# DIXON ENGINEERING, INC.

**Maintenance Inspection**

150,000 Gallon Spheroid

Ontonagon, Michigan

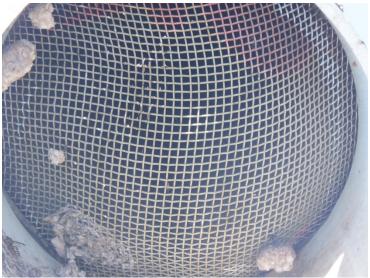
1) The concrete foundation is in good condition with no significant deterioration.

2) The grout between the steel baseplate and concrete foundation is intact.

3) The anchor bolts are in good condition.

Coat the exposed concrete with an epoxy coating system to help prevent deterioration. The cost would be incidental to exterior painting.

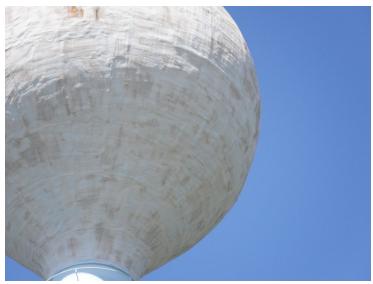
7) The screen at the overflow pipe discharge is intact but oversized.

8) There are a few coating failures on the baseplate.

10) There are a few minor coating failures on the basebell.

12) The basebell coating is in good condition overall.

Replace the screen at the overflow pipe discharge to meet current EGLE requirements. The cost would be incidental to the next painting project or could be performed by inhouse personnel.

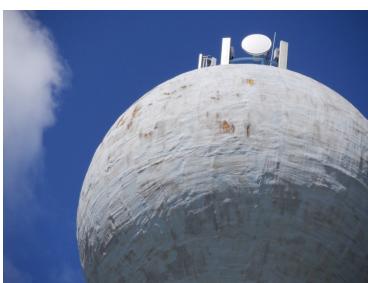
17) The bowl is covered with spray foam insulation. The coating on the insulation is in fair condition.

20) The sidewall is covered with spray foam insulation. The coating on the insulation is in fair condition.

Budget for exterior coating removal and repainting on the basebell and riser in approximately one to two years or when aesthetics dictate. Fading will continue and more coating failures will occur decreasing the tank's aesthetic appearance. Repair any damaged insulation on the ball and apply an acrylic system.

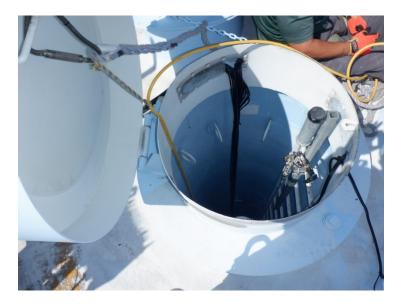
25) The insulation on the roof has deteriorated.

27) The coating on the roof insulation is in fair condition with areas of erosion.

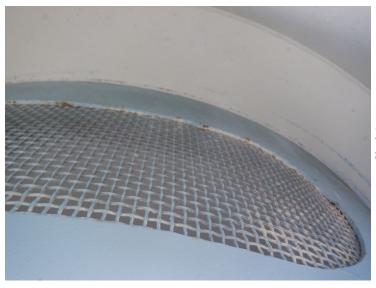
32) There is no handhold at the access tube roof hatch.

33) Antenna cables are routed through the screens on the access tube roof hatch neck. The screen are oversized.

Reroute the antenna cables through penetrations equipped with rubber boots on the roof. The estimated cost is \$3,000.

Install handholds at the wet interior roof hatch, at the access tube roof hatch, and above the painter's (bird) hatch. The handholds would assist the climber while entering and exiting the openings. The cost would be incidental to the next painting project.

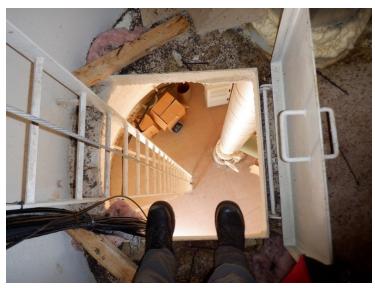
39) The interior roof vent screen is in good condition but oversized.

43) The sample tap on the fill/draw pipe in the basebell has a threaded end.

Replace the roof vent screens with 24 mesh screens to meet current EGLE requirements. The cost would be incidental to the next painting project or work could be performed by in-house personnel.

Replace the threaded sample tap on the fill/draw pipe with a smooth ended sample tap to meet current EGLE requirements. The work can be performed by in-house personnel.
